Docket Item #s 10 & 11  
BAR CASE # 2009-0016 &  
BAR CASE # 2009-0017

BAR Meeting  
March 4, 2009

**ISSUE:** Addition and alterations and Waiver of HVAC Screening Requirement

**LOCATION:** 117 South Lee Street

Figure 7. Proposed demolition in elevation.

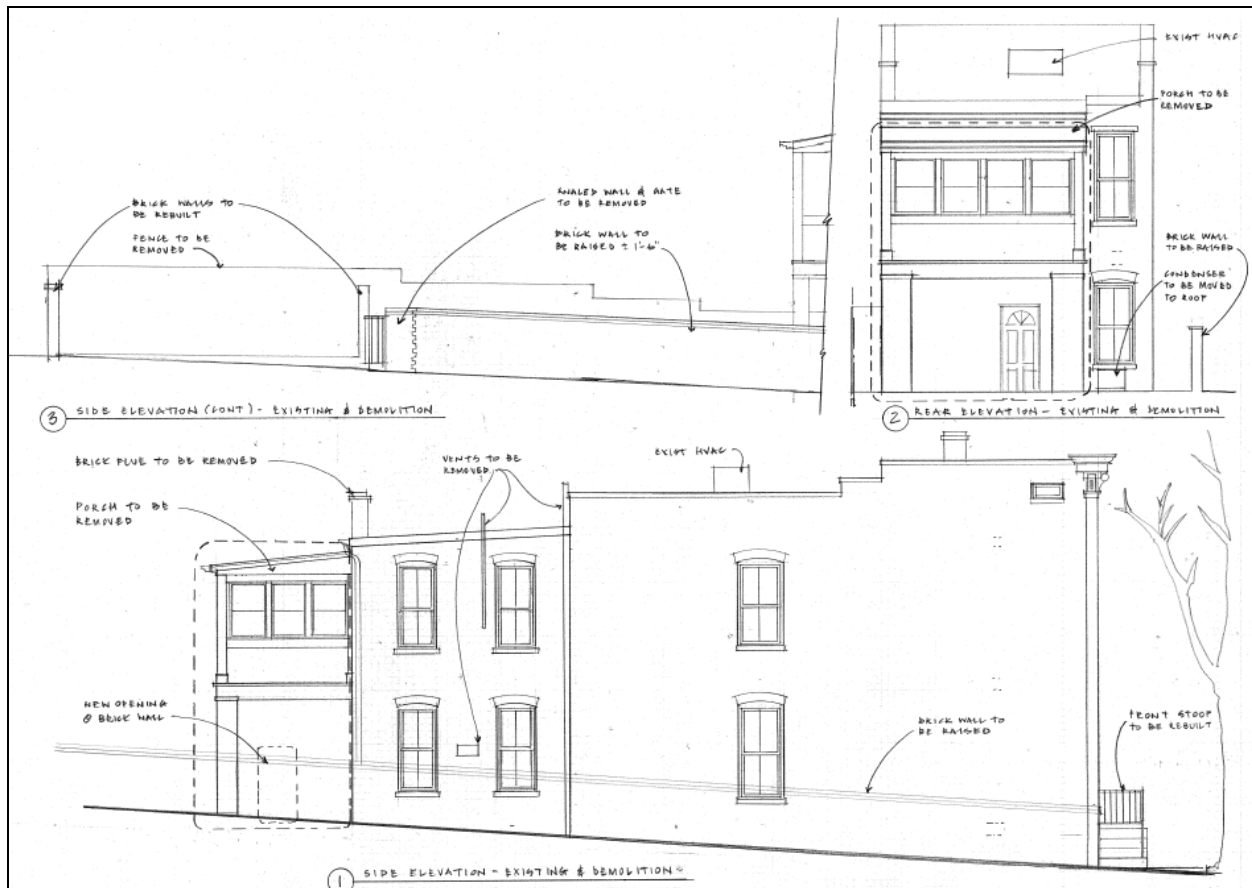
Regarding the demolition of the brick flue, the *Design Guidelines* indicate that “existing chimneys should be maintained *in situ* and not removed without a compelling reason and substantial justification.” The applicant has not provided a compelling reason for demolition of the chimney/flue. While the flue is not original to the building, Staff finds that it possibly is still considered historic (50 years or older) and should be retained as part of the evolution of the building.

Figure 10. Proposed elevations: side (south) and rear (west).

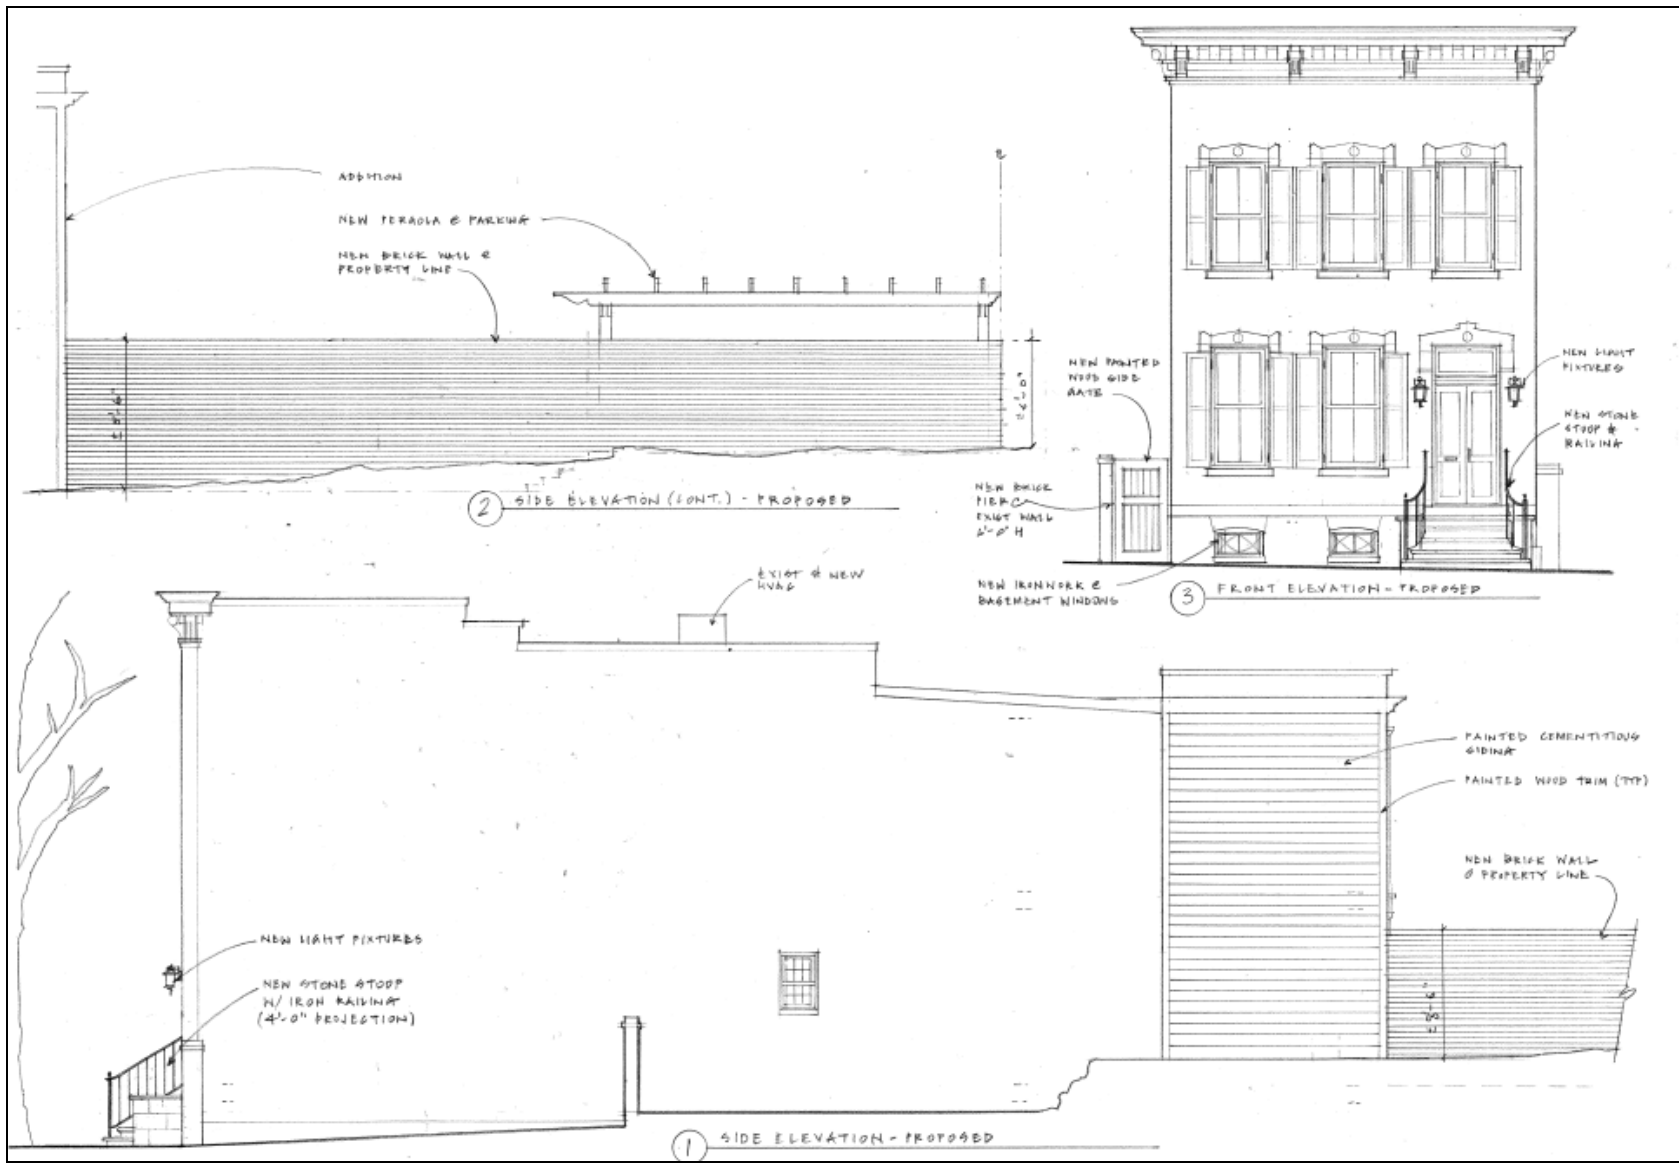
Staff has expressed concerns to the applicant regarding the height and massing of the proposed addition. Specifically, Staff finds that an addition should be no wider than the existing historic house (21' at the addition, 14.7' at the rear ell and 20' at the main block). While appropriate, and even encouraged, to differentiate new construction from historic fabric, Staff finds that the extension of the addition beyond the historic building's wall plane is inappropriate and overwhelms the existing structure. A more common form of differentiation would be offsetting the addition to have it step in from the historic house. Moreover, the addition is already appropriately differentiated from the historic house through the change of materials and shift in architectural vocabulary. Generally, additions should be subordinate to a historic building, specifically in regard to height. As proposed, the addition is approximately 2.5' higher than the rear of the house. The pronounced entablature on the addition likely will draw attention to the increased height of the addition. Staff has no objection to the proposed pergola adjacent to the rear ell and connecting the addition and main block and finds that it will not overwhelm the historic building and serves as a transitional element between the new construction and historic fabric.

While the use of true divided light wood windows and doors are preferred for the addition and consistent with the *Design Guidelines*, Staff recommends that a different light pattern be studied for the windows. The two-over-two windows, intended to relate to the two-over-two historic windows on the dwelling, have a slightly different proportion than what would typically be found on a classically detailed addition such as this. Staff recommends that other windows be considered before making a decision to continue with the two-over-two light pattern.

Regarding shutters, the *Design Guidelines* state that "decorative window and door shutters that are not operable are strongly discouraged" and that "shutters should be appropriate to the period of the structure." The use of fixed shutters in this manner is a unique design solution for the treatment of the solid wall space. Shutters are appropriate for an enclosed porch and represent traditional building patterns. While the use of inoperable shutters as proposed may ultimately be acceptable in this circumstance, Staff finds that this treatment should be further studied.

1. That the applicant restudy the height and massing of the proposed addition so that it fits within the wall plane of the historic building and is no taller than the portion of the historic house immediately adjacent;
2. That the applicant continue to study the proposed window and shutter scheme;
3. That the applicant eliminate any alterations or demolition to the historic garden wall on the south (alley) elevation and should reuse all historic brick on the altered garden wall located at the west (rear) property line;
4. That the applicant revise the new garden wall on the north property line to be no more than 6' in height from grade by stepping the wall down accordingly with existing grade; and,
5. That the applicant should continue to work with Staff in developing design details as they relate to the shed, addition and other alterations.

Figure 12. Proposed alterations to rear yard area including garden walls, pergola and shed.

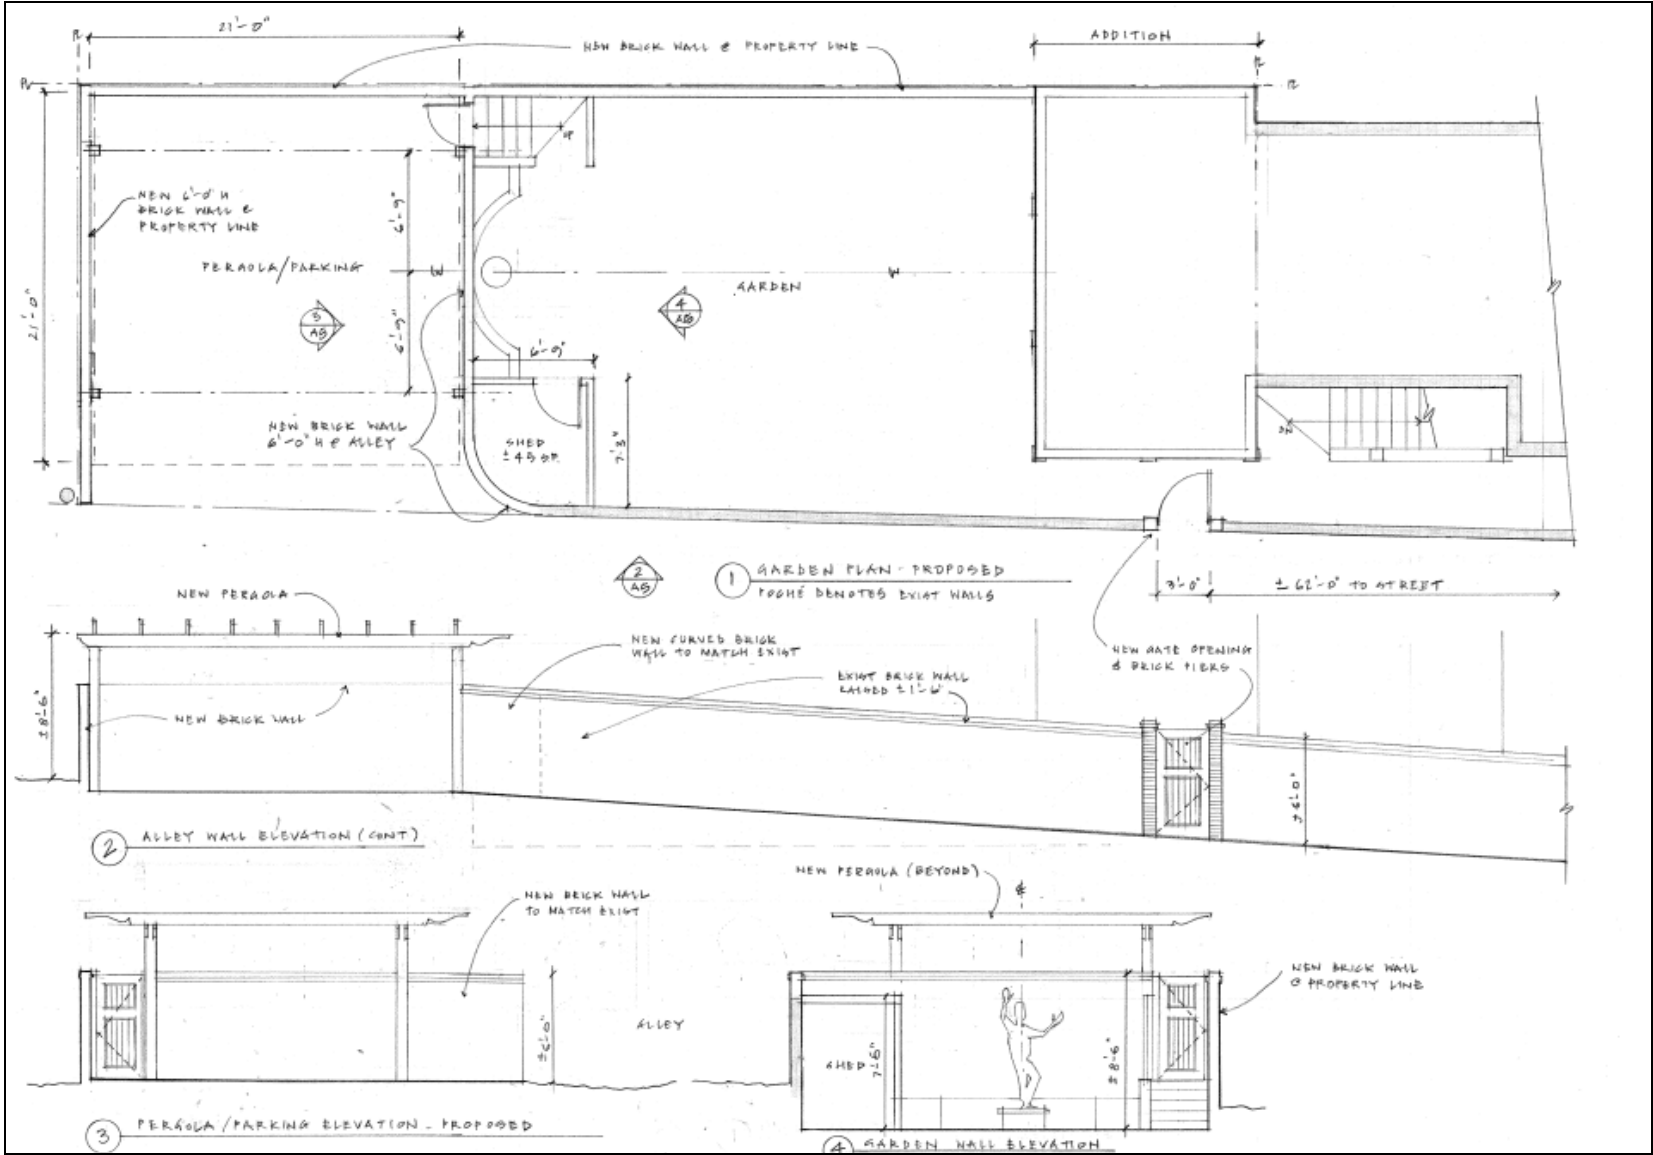
The *Design Guidelines* pronounce that “an important visual feature of the historic districts are the fences, garden walls and gates that define property lines...[and] serve as a distinctive feature of the streetscape and individual yards.” Staff is very concerned regarding the proposed demolition and alterations of the historic garden wall on the alley (south) property line. In Staff’s opinion, the proposed additional height to the historic garden wall and the proposed piers are inappropriate. Adding 18” of brick to the existing wall not only erodes the historic integrity of the existing garden wall but also disrupts the distinct vantage points resulting from looking through alleyways from streets – a definitive characteristic of block porosity in the historic district. Furthermore, Staff finds that the new brick garden wall on the north and west property lines should be no higher than 6’ at grade at the property line. Specifically, Staff does not support the height of the new garden wall at 8.5’ on this property line. Section 7-802 of the Zoning Ordinance permits the BAR to waive the requirements of fence height as stated in the Zoning Ordinance “where to do so would be consistent with the historic character of the district.” The applicant has not presented a compelling argument as to why an 8.5’ garden wall at this location is consistent with the historic character of the district. Staff recommends restudy of this garden wall to step it down with existing grades along the property line.

Staff finds the proposed pergola over the parking area to be appropriate in design, scale and materials. The proposed alterations to the garden area, including the shed, are generally appropriate. Due to the reduction in grade in the rear yard, the shed will be minimally visible. With the exception of the proposed new gate on the alley elevation, the proposed painted wood gates are appropriate. Staff recommends elimination of the gate on the alley elevation to minimize demolition of the historic wall.
